ADDENDUM NO. 2

PROJECT NAME: **CREIGHTON STREET IMPROVEMENTS - (40-00252)**

DATE: August 2, 2012

STANDARD CURB DRAIN

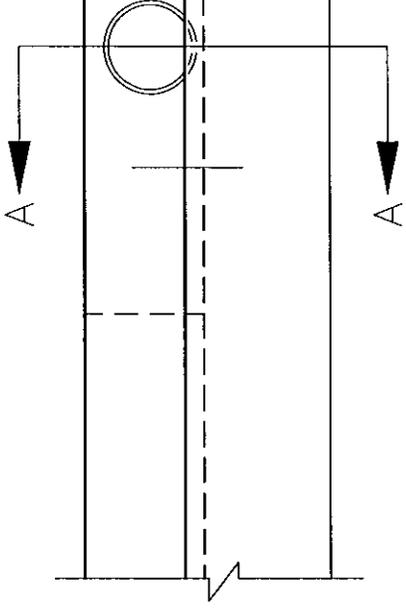
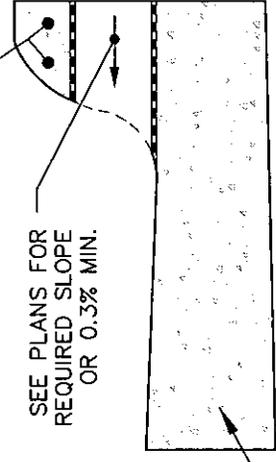
7. What is the curb drain on sheet 33?
Response: See attached *Standard Curb Drain* and *Pipe Drain Detail*.
